Application Number: 10/617,083

Appellant(s): LEE, PEI-YUAN

EXAMINER'S ANSWER

Diagram 1. Figure 8 of Brennan labeled with the elements exactly as defined in appellant's specification, especially Figure 2(c).

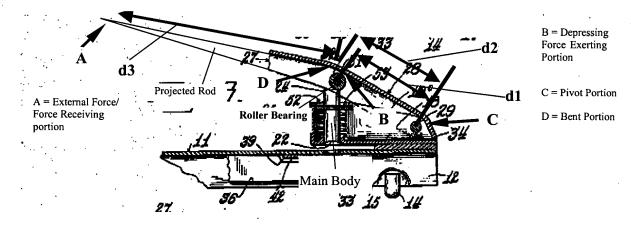
Appellant asserts that roller 32 of Brennan is coupled to the bent portion instead of being coupled to a depressing-force exerting portion, whereas claim 16, lines 13-14, and claim 22, lines 13-15, of the instant application define the depressing-force exerting portion is disposed between and and only between the pivot portion and the bent portion as recited in claim 16, lines 13-14, and claim 22, lines 13-15. Appellant further asserts that there exists a short rod between the bent portion D and the roller 21 in figure 2(a) of the instant application. In order to clearly demonstrate the Examiner's interpretation of Brennan, figure 8 of Brennan is labeled with the elements in question of claims 16 and 22 below.

As shown in Diagrams 1 and 2 above, Brennan discloses that a depressing force exerting portion (B) is between and disposed only between the pivot portion (C) and the bent portion (D) and coupled to the roller bearing for transmitting the roller bearing to depress the main body while moving in response to the external force. It should be emphasized that the roller bearing 32 of Brennan is attached to the levering rod slightly to the right of the bent portion. Moreover, there exists a short rod between pivot portion (C) and bent portion (D) illustrated by d2 being greater than d1 in Diagram 1.
